TEXAS COMMISSION ON ENVIRONMENTAL QUALITY AGENDA ITEM REQUEST

CAPTION: Docket No. 2023-1223-SIP. Consideration for adoption of Houston-Galveston-Brazoria Severe Area Attainment Demonstration State Implementation Plan (SIP) Revision for the 2008 Eight-Hour Ozone National Ambient Air Quality Standard.

HGB 2008 Ozone NAAQS Severe AD SIP Revision Non-Rule Project No. 2023-110-SIP-NR

HOUSTON-GALVESTON-BRAZORIA SEVERE AREA ATTAINMENT DEMONSTRATION STATE IMPLEMENTATION PLAN REVISION FOR THE 2008 EIGHT-HOUR OZONE NATIONAL AMBIENT AIR QUALITY STANDARD

Figure 3-1: Exceedance Days in the HGB 2008 Ozone NAAQS Nonattainment Area by Year from 2012 through 2022

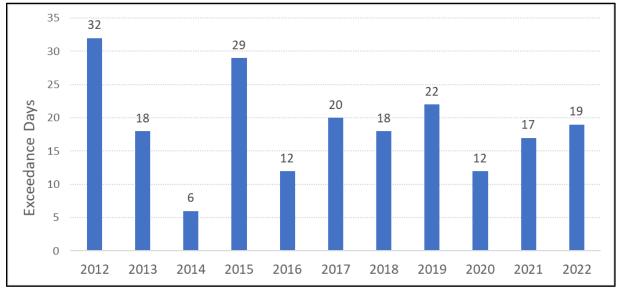
EPA commented that 2021 should have been evaluated as a suitable base case episode year for HGB, rather than relying on a 2019 base case episode. EPA stated that the discussion associated with Figure 3-1 in Chapter 3 of this SIP revision is not adequate to justify relying on 2019 for the base case episode because more exceedance days

The commission disagrees with EPA's statement that the discussion associated with Figure 3-1 is not adequate. Section 3.2: *Modeling Episode* of this SIP revision

Figure 3-8: Difference in Anthropogenic NO_x between 2026 Future Case and 2019 Base Case on June 12 Modeled Episode Day

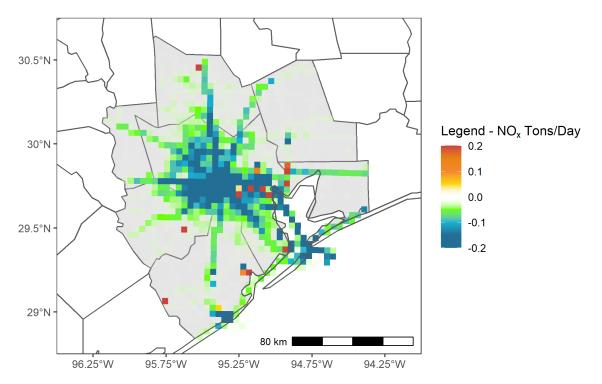
EPA commented on the maximum and minimum values depicted in the legend in Figure 3-8: *Difference in Anthropogenic NO_x between 2026 Future Case and 2019 Base Case on June 12 Modeled Episode Day*, located in this SIP revision, and wanted to make sure that emissions values in each grid cell are contained within the legend values.

The maximum and minimum legend values in Figure 3-8 indicate concentrations greater than or equal to +0.2 tpd and less than or equal to -0.2 tpd respectively. For example, dark blue depicts grid cells that experience a negative change of at least 0.2 tpd between 2019 and 2026, and dark red depicts grid cells that experience a positive change of at least 0.2 tpd between 2019 and 2026. So, it is likely that grid cells shown in either color have values much greater than the 0.2 tpd or much less than the -0.2 tpd.

A footnote will be added to Figure 3-6 in Appendix A to clarify this information about the figure legends.

Figure 3-10: NMB for MDA8 Ozone of at least 60 ppb in April through October 2019

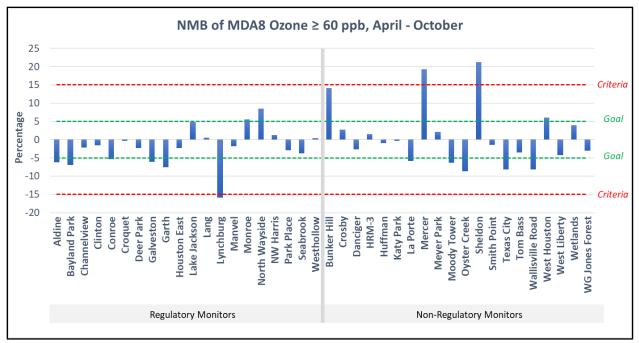
Figure 3-10: *NMB for MDA8 Ozone of at least 60 ppb in April through October 2019* and Table 3-7: *Benchmarks for Photochemical Model Performance Evaluation Statistics* in Section 3.5 clearly shows that 19 of the 20 regulatory monitors meet the 15% target with the NMB while 13 of the monitors are within 5%, and six

Figure 3-10 in Section 3.5 shows that 19 of the 20 regulatory monitors clearly meet the 15% target with the NMB for 13 of the monitors within 5%, and six monitors within a range of 6-8%. On page 3-15, the SIP revision explicitly states that "all regulatory monitors in the HGB 2008 ozone NAAQS nonattainment area have NMB within the criteria range except Lynchburg." For purposes of demonstrating attainment, the Lynchburg Ferry monitor is not of concern because it has historically measured relatively low ozone levels and has had a design value of 70 ppb or less since 2013. As of 2023, Lynchburg Ferry has an ozone design value of 70 ppb, and follows the 2008 eight-hour ozone NAAQS of 75 ppb.

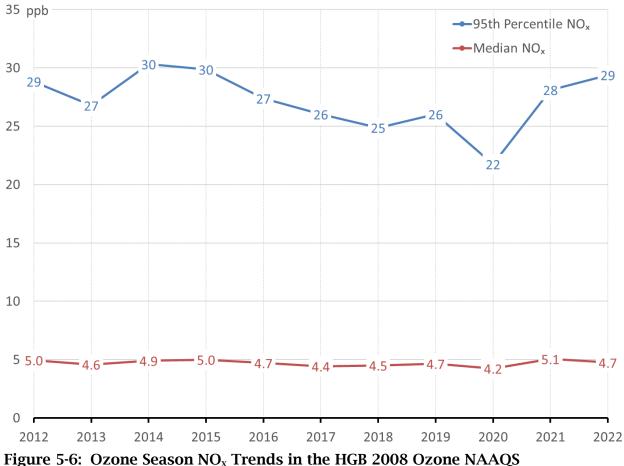
Air Alliance Houston, Earthjustice, Environment Texas, Sierra Club, and TEJAS commented that the ambient NO_x concentration levels have hardly budged since 2012, citing Figure 5-6: *Ozone Season NO_x Trends in the HGB 2008 Ozone NAAQS Nonattainment Area* on page 5-12 of the SIP narrative. The commenters also stated that the on-road and non-road fleet turnover benefits for NO_x emissions referenced in Chapter 5 of this SIP revision have been subsumed by a 7% increase in point source NO_x emissions from 2012 to 2021, citing Figure 5-7: *HGB 2008 Ozone NAAQS Nonattainment Area Point Source NO_x Emissions by Site* on page 5-14 of the SIP narrative and page 3-1 in Appendix B.

Figure 5-8: Ozone Season Median and 95th Percentile TNMOC and HRVOC Trends in the HGB 2008 Ozone NAAQS Nonattainment Area

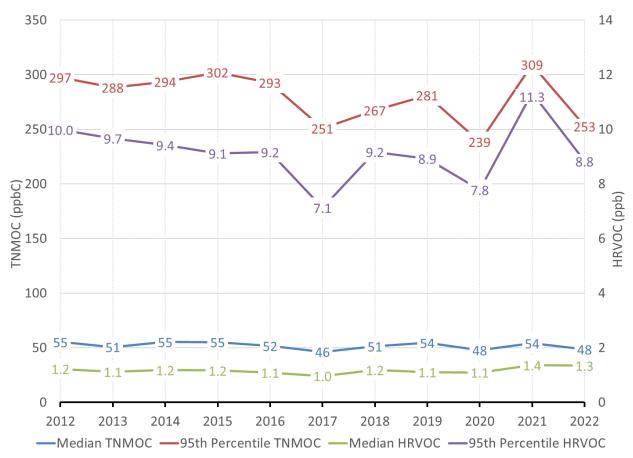
Air Alliance Houston, Earthjustice, Environment Texas, Sierra Club, and TEJAS commented that ambient total non-methane volatile organic compounds (TNMOC) and HRVOC concentration levels are stagnated or increased from 2012 to 2022 based on the Figure 5-6 of SIP narrative and cites page 5-16 of the SIP narrative where it is stated that the 11 largest VOC emitters in the HGB area had "almost no change" in emissions from 2012 through 2022. The commenter cites an increase of 4.62 tons per day (tpd) in modeled VOC from 2019 to 2026 in Table 3-6: *June 12 Episode Day 2026 Future Year Anthropogenic Modeling Emissions for the HGB 2008 Ozone NAAQS Nonattainment Area* on page 3-12 of the proposed SIP revision and stated the 2019 and 2026 VOC emissions increase is due primarily to the non-road, area, and point source categories. The commenter cited pages 5-15 and 5-17 of this SIP revision to support the statement that HRVOC emissions are stagnated or increased. The commenter concluded that these trends reinforce that ozone improvements in the Houston area have ceased in the last decade.
